**GM Product  
Development**

July 28, 2011

GM GDM system saved title: "IVD\_2011\_GMT610\_Addendum\_AMD-UVWR"

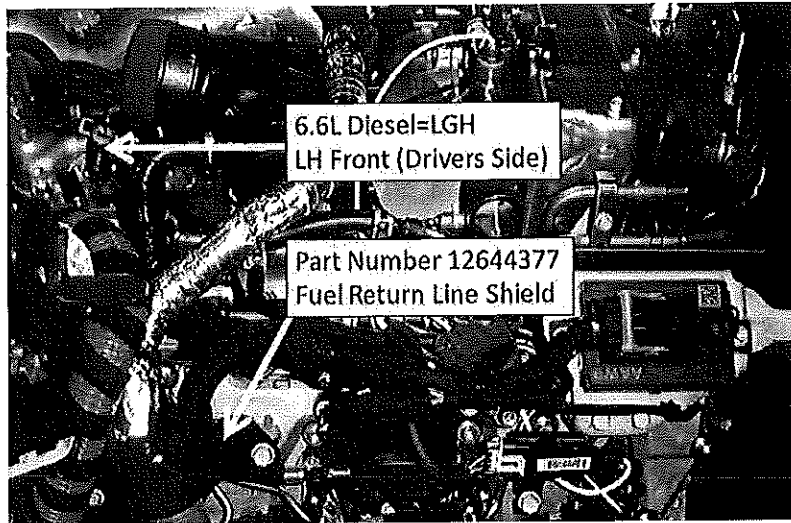
\*NOTE: GM began installation of Part Number 12644377 Fuel Return Line Shield as a running change during the 2011 MY. As a result, a definitive VIN breakpoint is not available for this change. Before ordering the Fuel Return Line Shield, please verify if the part was installed by GM. The two (2) photos that follow are intended to assist your verification of the Fuel Return Line Shield installation as originally manufactured by GM.
